# Microcontroller Technical Information

PG-FP4 Flash Memory Programmer  Usage Restrictions		Document No.	ZBG-CD-07-0029	1/2
		Date issued	May 21, 2007	
		Issued by	Development Tool Solution Group Multipurpose Microcomputer Systems Division Microcomputer Operations Unit NEC Electronics Corporation	
Related documents	PG-FP4 User's Manual: U15260EJ4V0	Notification classification	√	Usage restriction
				Upgrade
				Document modification
				Other notification

### PG-FP4 Flash Memory Programmer Usage Restrictions

# Operating Precautions for PG-FP4

**Figure 2-6. Connection Diagram**

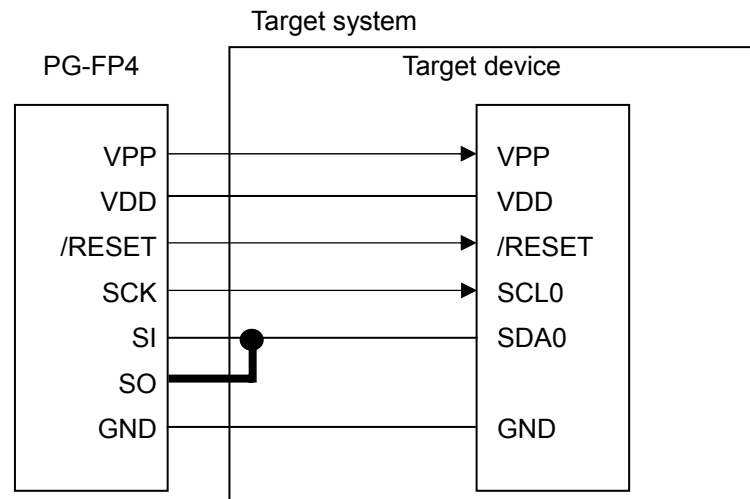
The adapter board for IIC communication mode that is included with the PG-FP4 has been changed to the IIC/78K0S/KX1+ adapter in control code G and later. In conjunction with this change, replace the following descriptions with section **2.3.9**.

When I<sup>2</sup>C communication mode is used and the IIC/78K0S/KX1+ adapter is not used, short the SI pin and SO pin in the target system.

**Figure 2-7. Connection Diagram When Using IIC/78K0S/KX1+ Adapter**

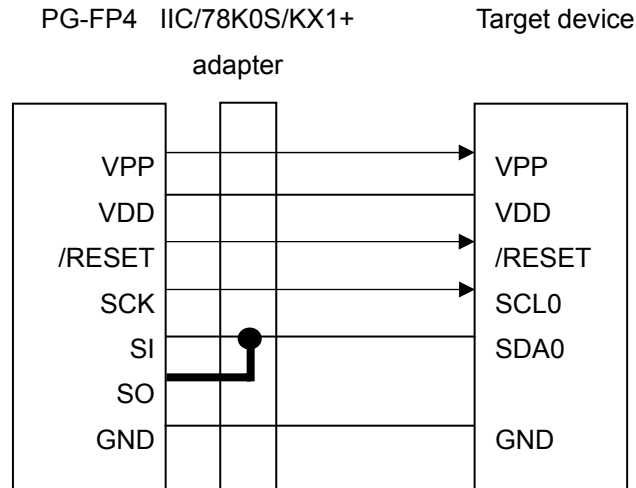
When I<sup>2</sup>C communication mode is used and the IIC/78K0S/KX1+ adapter is used, shorting the SI pin and SO pin in the target system is not required.

**Figure 2-8. Connection Diagram When Using IIC/78K0S/KX1+ Adapter**

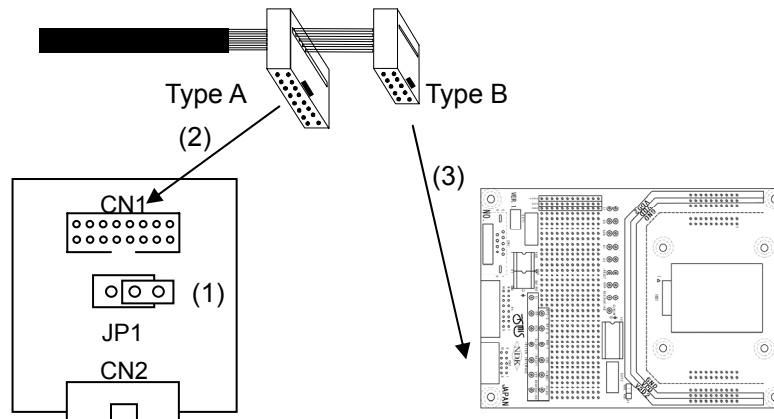
<Usage when writing to two-power-supply flash memory microcontroller>

- (1) Leave JP1 open.
- (2) Connect the program adapter and target connector type B (10 pins) of the target cable.
- (3) Connect target connector type A (16 pins) of the target cable and the IIC/78K0S/KX1+ adapter (CN1).

**Figure 2-9. Connection Diagram When Using IIC/78K0S/KX1+ Adapter**

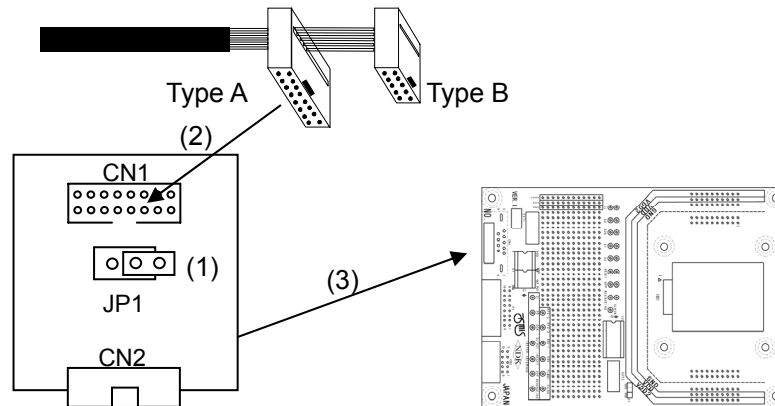
<Usage when writing to single-power-supply flash memory microcontroller>

- (1) Leave JP1 open.
- (2) Connect target connector type A (16 pins) of the target cable and the IIC/78K0S/KX1+ adapter (CN1).
- (3) Connect the program adapter and the IIC/78K0S/KX1+ adapter (CN2).

**Figure 2-10. Connection Diagram**

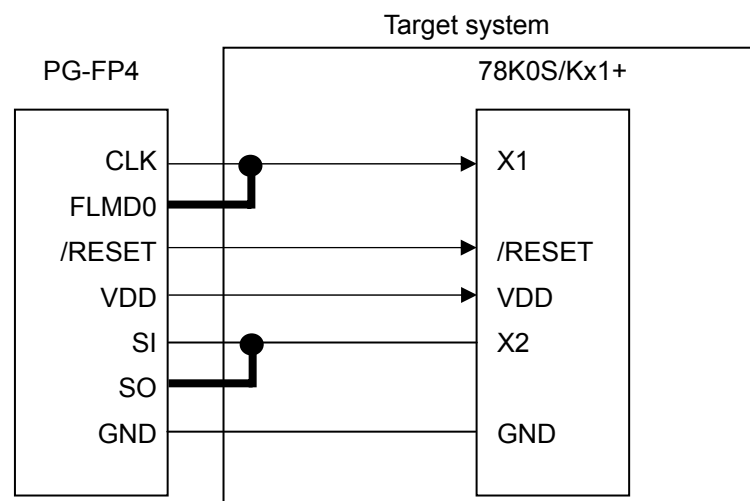
When the 78K0S/KX1+ is used and the IIC/78K0S/KX1+ adapter is not used, short the SI pin and SO pin, as well as the CLK pin and FLMD0 pin in the target system.

**Figure 2-11. Connection Diagram When Using IIC/78K0S/KX1+ Adapter**

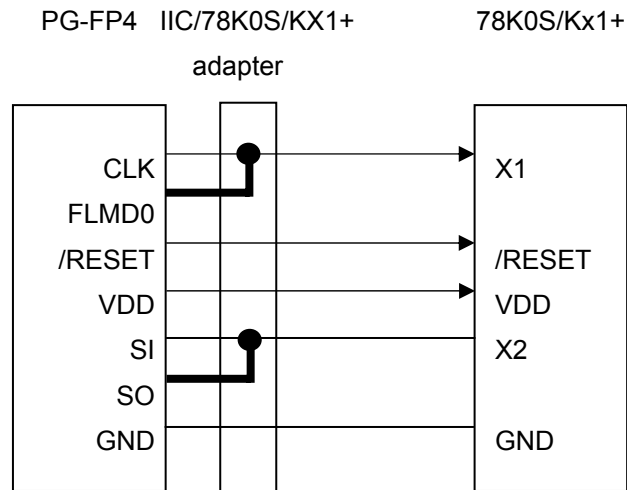
When the 78K0S/Kx1+ is used and the IIC/78K0S/KX1+ adapter is used, shorting the SI pin and SO pin, as well as CLK pin and FLMD0 pin in the target system is not required.

**Figure 2-12. Connection Diagram When Using IIC/78K0S/KX1+ Adapter**

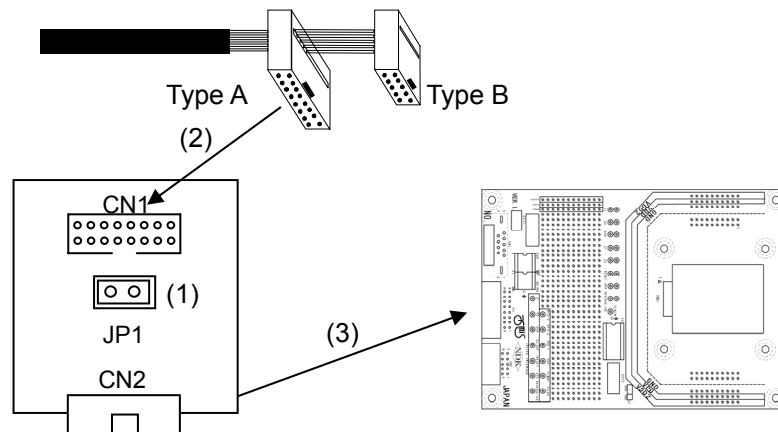
<Usage when writing to 78K0S/Kx1+>

- (1) Short JP1.
- (2) Connect the target connector type A (16 pins) of the target cable and IIC/78K0S/KX1+ adapter (CN1).
- (3) Connect the FA adapter with the IIC/78K0S/KX1+ adapter (CN2).

### (3) [Checksum] menu specifications

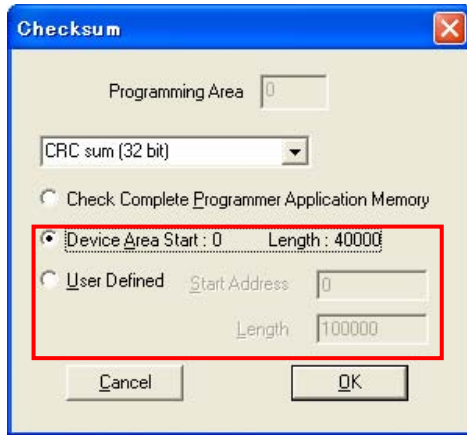
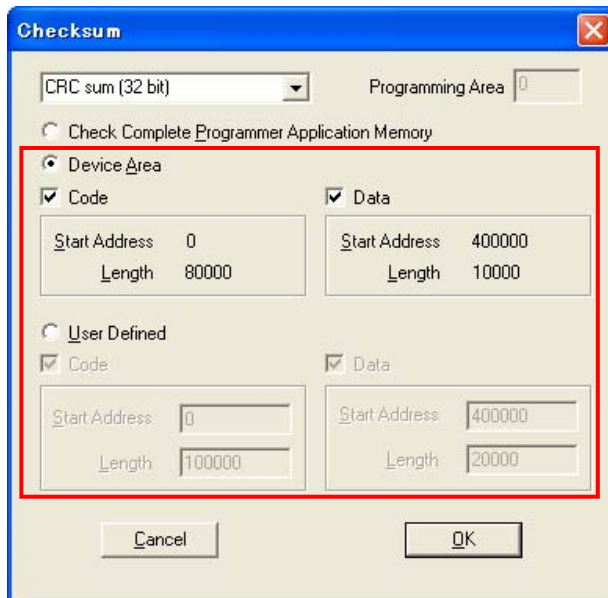
When [Checksum] in the [File] menu is executed, the window display varies depending on whether or not the downloaded parameter file supports the data flash area.

<When a parameter file that does not support the data flash area is downloaded>

After clicking the OK button, the following information will be displayed in the File Checksum area of the programmer parameter window.

<When a parameter file that supports the data flash area is downloaded>

After clicking the OK button, the following information will be displayed in the File Checksum area of the programmer parameter window.

#### (4) [HEX Editor] menu specifications

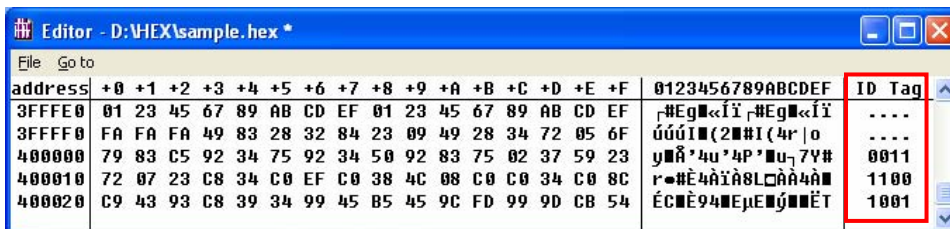
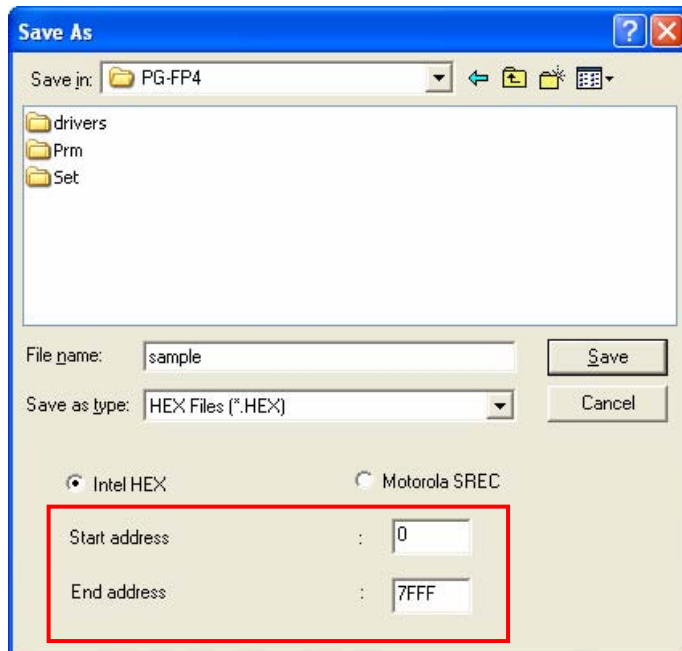
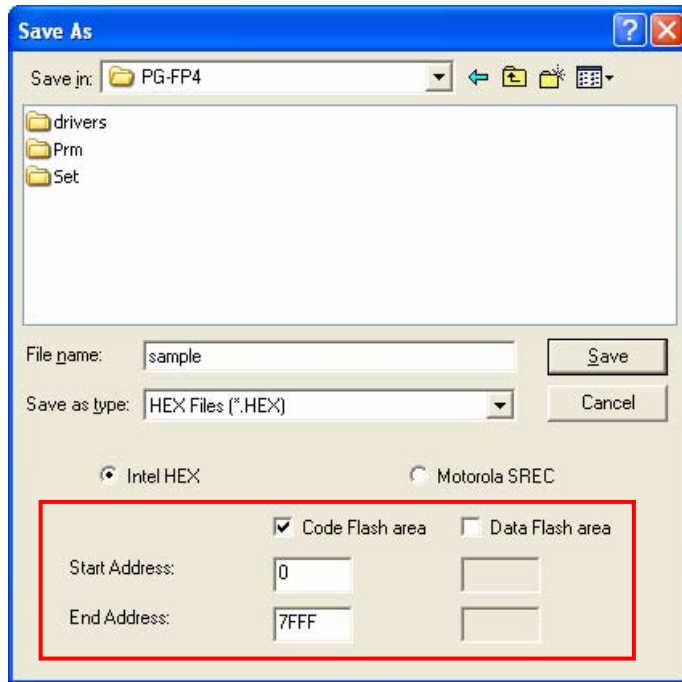
An ID Tag row has been added to the [HEX Editor] in the [File] menu. The ID Tag row is used in microcontrollers that support the data flash area. Only the values at addresses 400000h and beyond can be edited in the ID Tag row.

When a parameter file is downloaded using the [HEX Editor] and the file is saved as, the available options in the [Save As] window vary depending on whether or not the downloaded file supports the data flash area.

<When a parameter file that does not support the data flash area is downloaded>

<When a parameter file that supports the data flash area is downloaded>

## (5) Specifications for Standard tab in Device Setup window

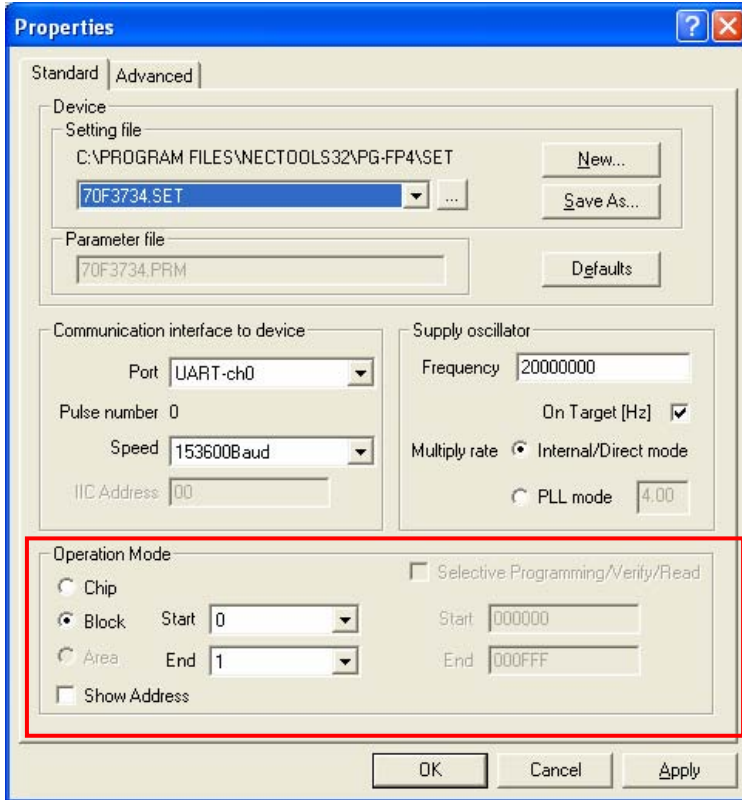
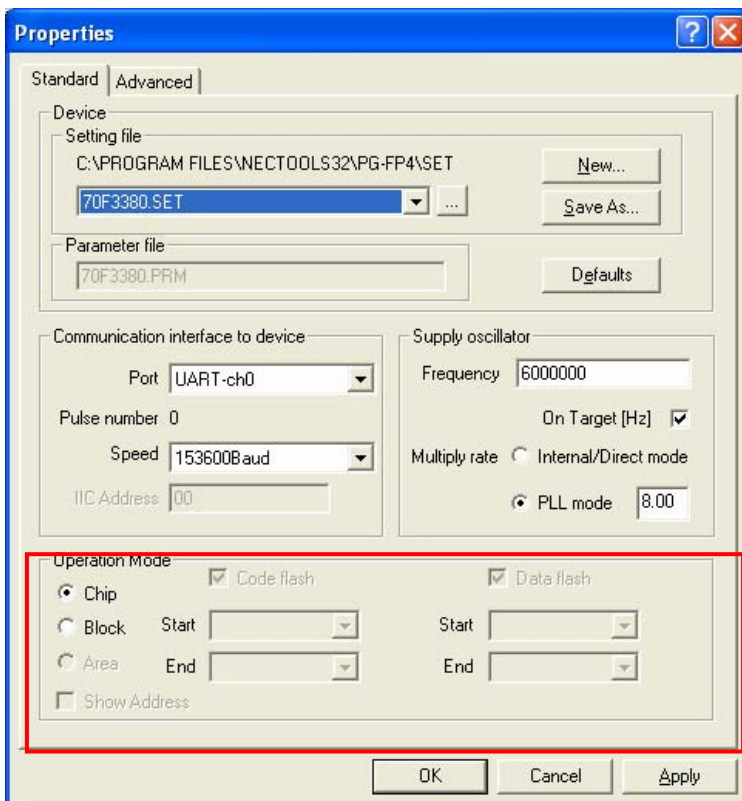
The available options on the Standard tab in the Device Setup window vary depending on whether or not the downloaded file supports the data flash area.

<When a parameter file that does not support the data flash area is downloaded>

<When a parameter file that supports the data flash area is downloaded>

## (6) [Upload from FP4] menu specifications

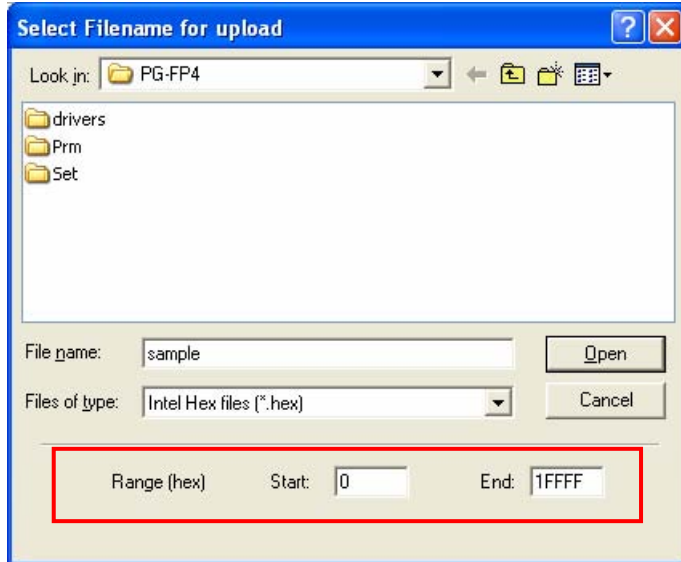
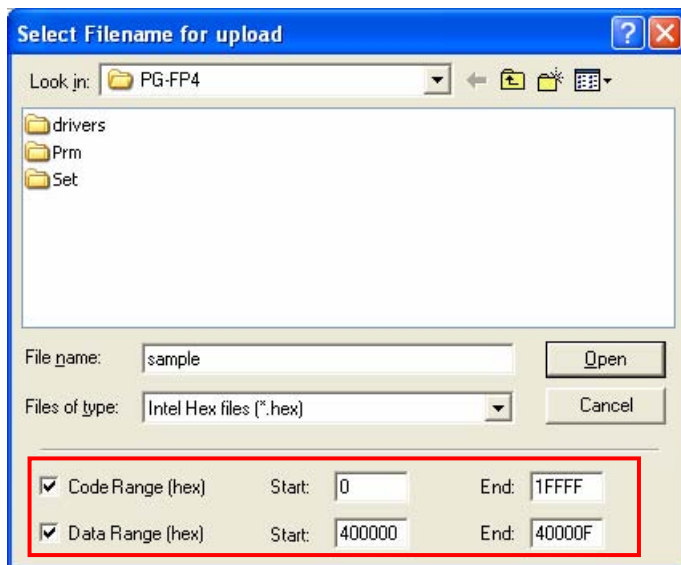
The available options in the “Select Filename for upload” window vary depending on whether or not the downloaded file supports the data flash area.

<When a parameter file that does not support the data flash area is downloaded>

<When a parameter file that supports the data flash area is downloaded>

**Caution** Specify twice the required for the data range in order to accommodate the ID tag data.

Layout of Advanced tab in Device Setup window

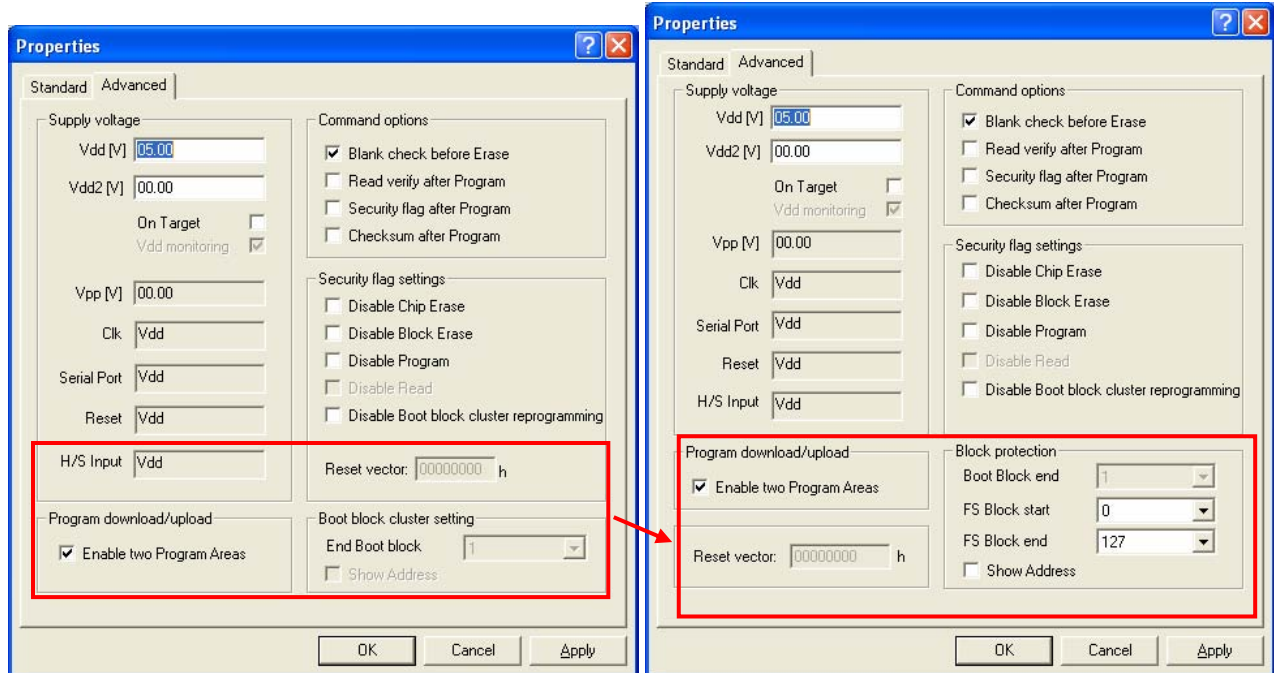
The 78K0R microcontrollers are supported in products with control code H (firmware: V1.36, GUI: V2.17) and later. In conjunction with this addition, the following boot block settings have been added.
